Submissions Report

Homebush Battery Energy Storage System

Client: Ausgrid

AECOM Australia Pty Ltd

FIGURE 4:
UPDATED PROJECT
LAYOUT

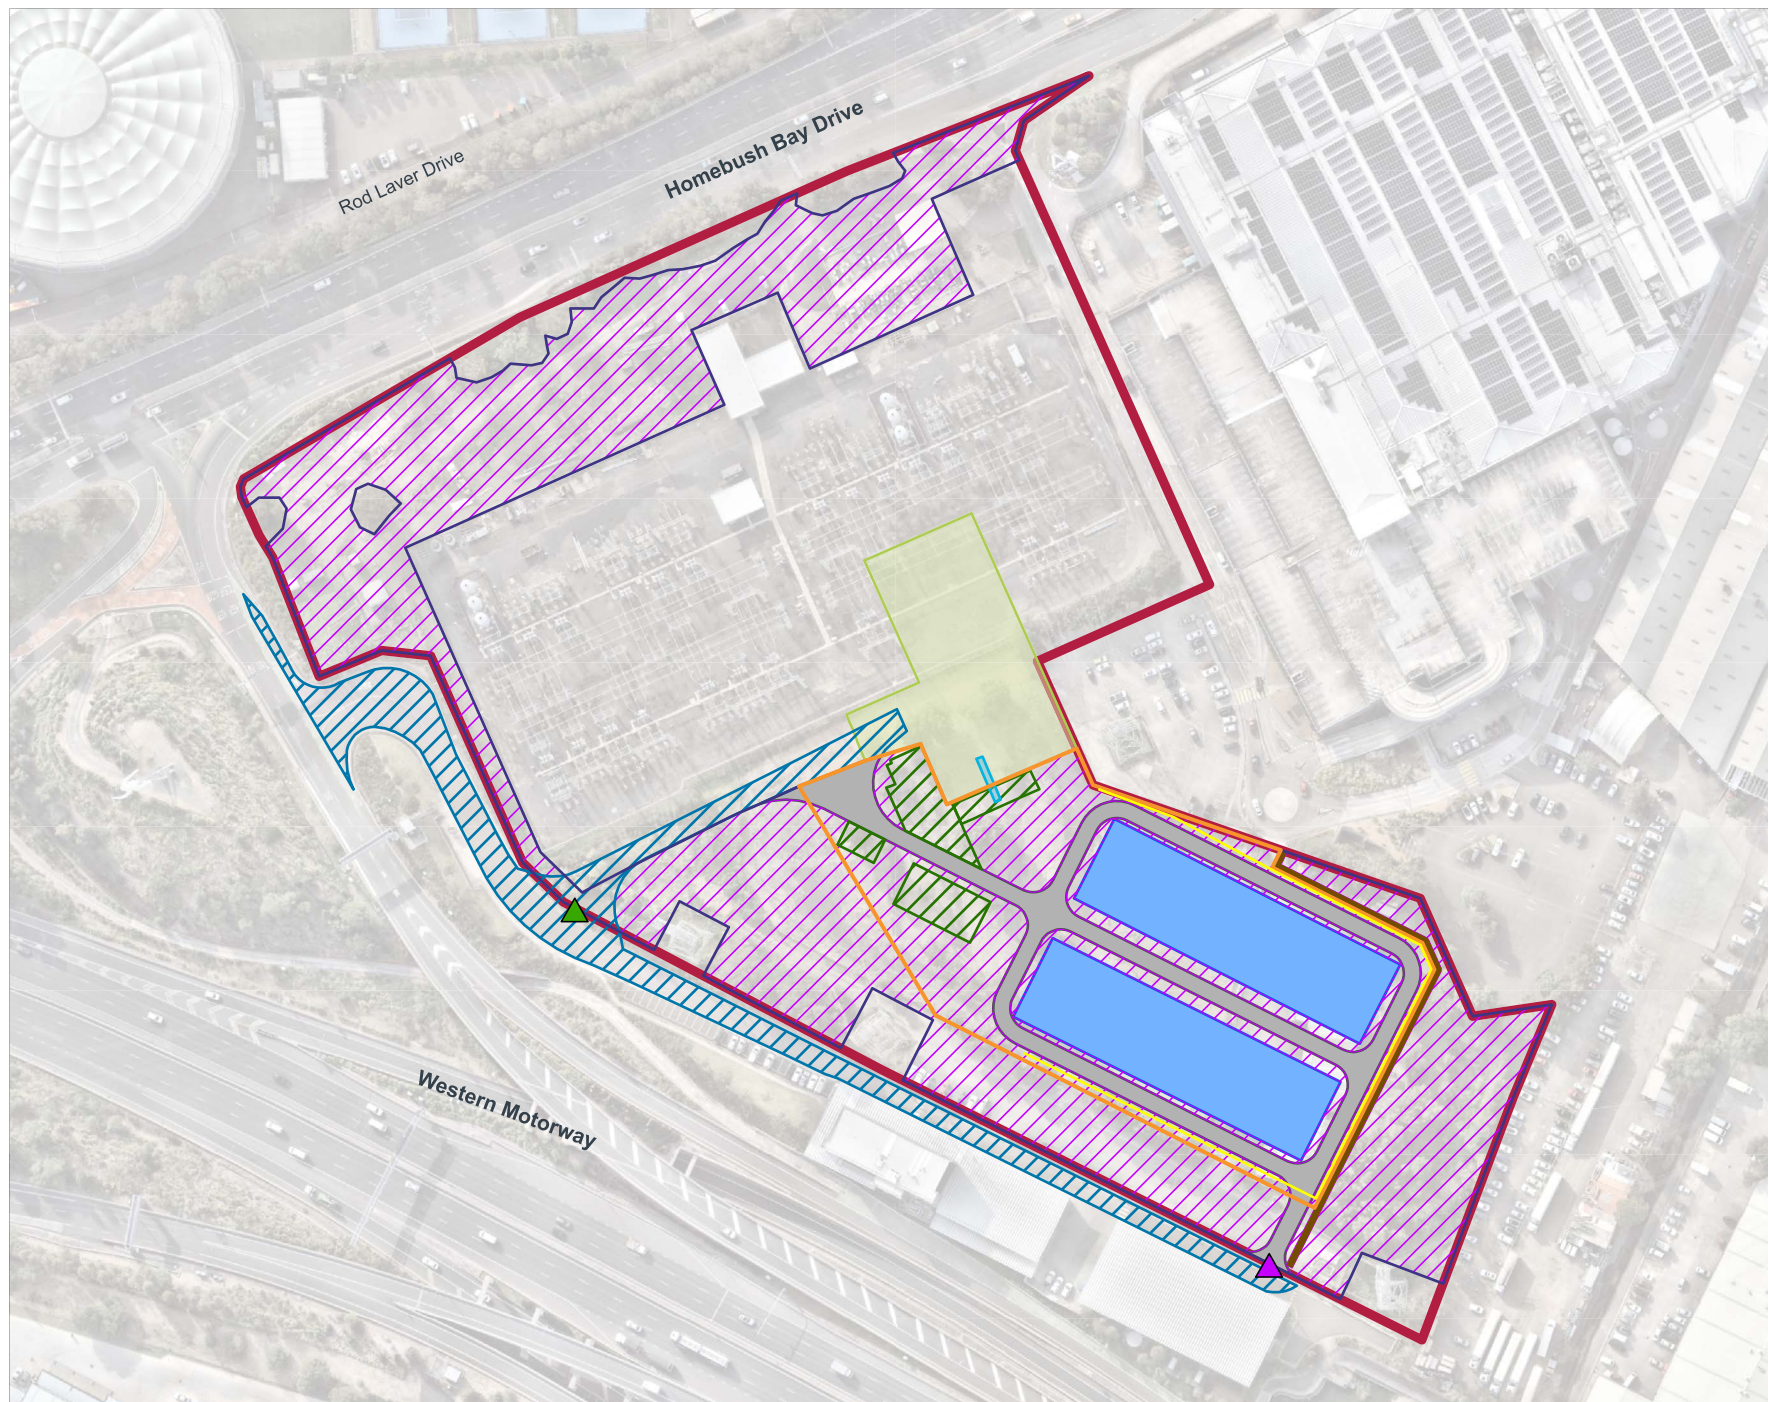
- DPHI Hazards consider that a front-facing separation distance between battery units of 2.44 m is inconsistent with the 3 m recommendation provided in NFPA 855: Standard for the Installation of Stationary Energy Storage Systems, which is generally accepted by DPHI Hazards as a reasonable separation distance. DPHI Hazards requested further information to provide justification for the proposed separation of the batteries by 2.44 metres. In addition, DPHI Hazards requested to reexamine the area allocated for the batteries and demonstrate that the layout allows for adequate spacing to minimise the risk of fire propagation.

In response to comments raised by DPHI Hazards, the area allocated for the batteries has been re-examined and the separation distances for the side, back, and front of the Megapack 2 XL units have been considered when developing the updated Project layout. The updated Project layout increases the front-facing separation distance between containerised battery units to 3 m, in line with the recommendation provided in NFPA 855. The updated layout and increased separation distance has been reviewed by Planager in the PHA Addendum (see **Appendix H**).

The PHA Addendum identifies that the updated Project layout results in a slight decrease in distance between the nearest containerised battery unit and the site boundary (from 16 m to approximately 12 m), however the heat radiation in a worst-case credible enclosure fire remains below the injury risk criteria specified in *Hazardous Industry Planning Advisory Paper No 4 – Risk Criteria for Land Use Safety Planning* (HIPAP No.4) and is not likely to be significant. Therefore, the updated layout allows for adequate spacing to minimise the risk of fire propagation.
